## 46. Reconciliation Sublayer (RS) and 10 Gigabit Media Independent Interface (XGMII)

*Change 46.1.7.3 for carrier indication definition:*

Figure 46–10a—Transmit LPI State Diagram

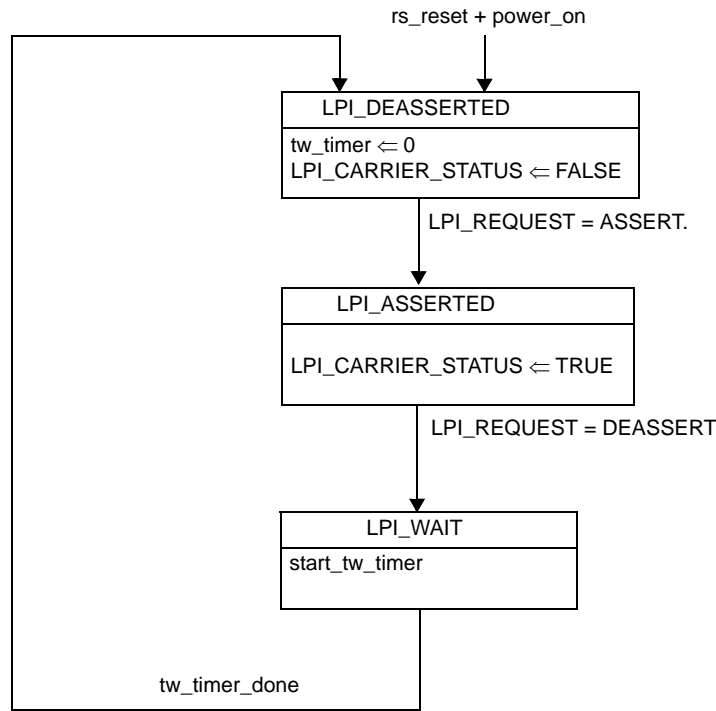
*Insert a new section, 46.3a before 46.4:*

The LPI\_CARRIER\_STATUS variable indicates how the CARRIER\_STATUS parameter is controlled by the LPI\_REQUEST parameter. The LPI\_CARRIER\_STATUS is either TRUE or FALSE as determined by the Transmit LPI state diagram in Figure 46-10a.
